April 4, 2023

**RE: Prairie Point Site Plan No 1 (Kings Point North) Third Submission Review Response to Comments**

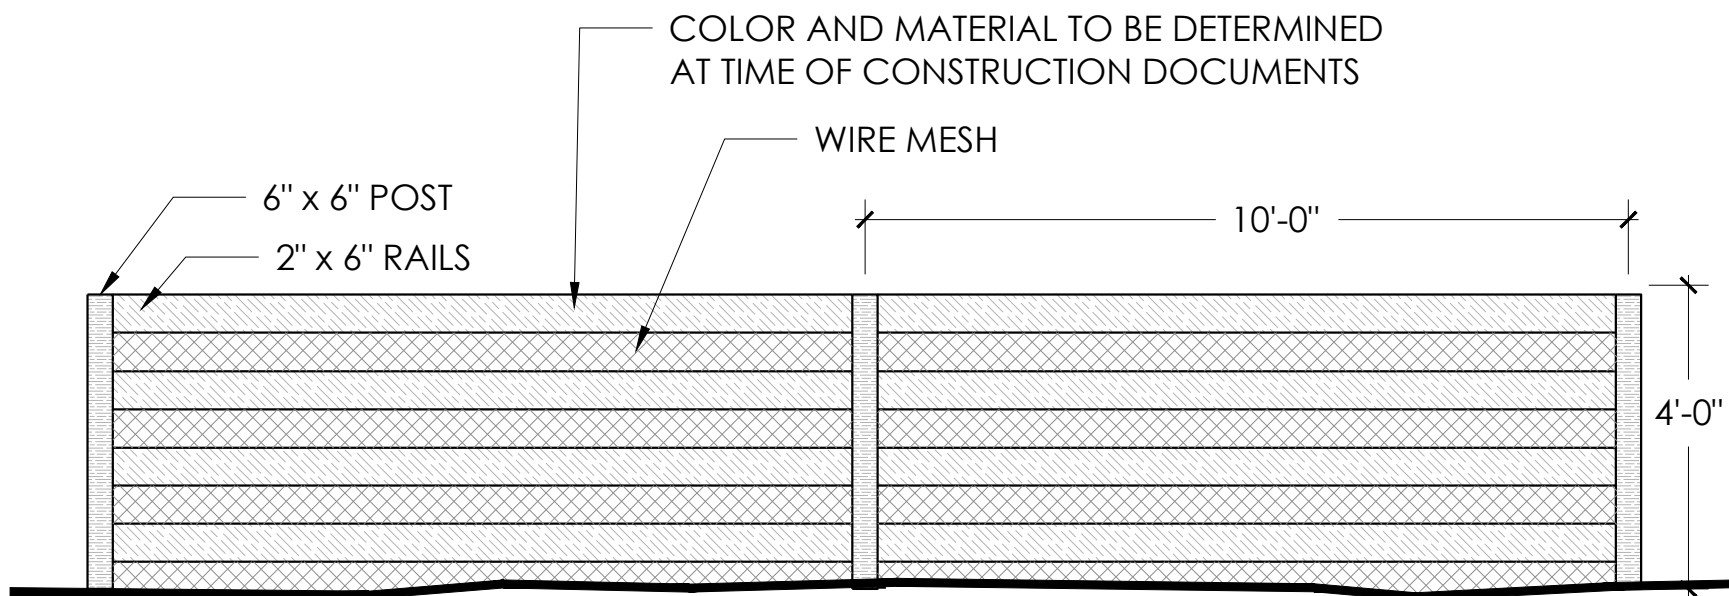
Provide specific material call-outs and colors for each detail. City staff does not have access to construction documents.

RESPONSE:  
MATERIAL CALL-OUT HAS BEEN PROVIDED.

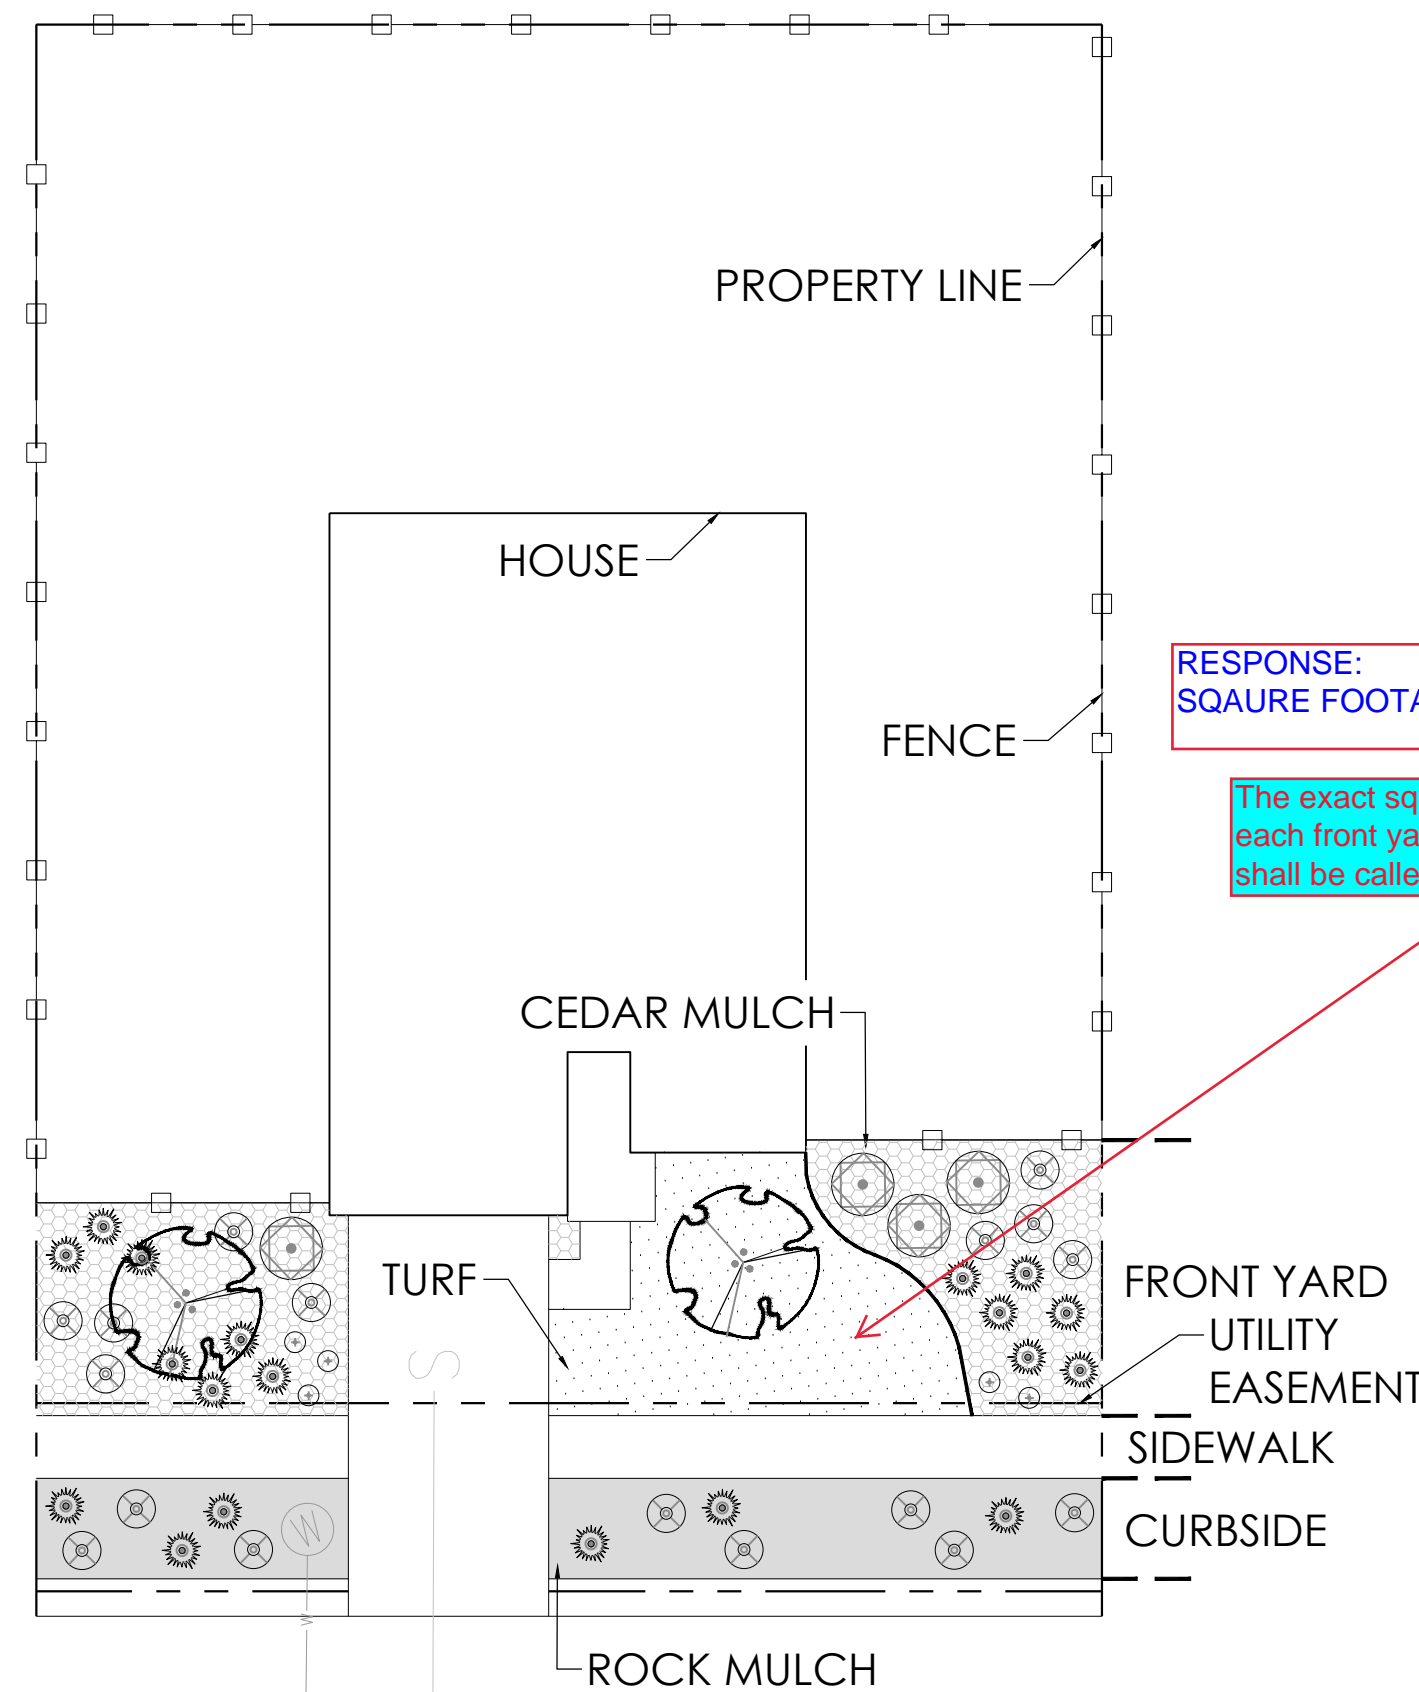
This graphic seems to indicate one ornamental tree and one shade tree. If this is the intent, show this in the planting typical on the previous sheet.

RESPONSE: NOTED AND ADJUSTED.
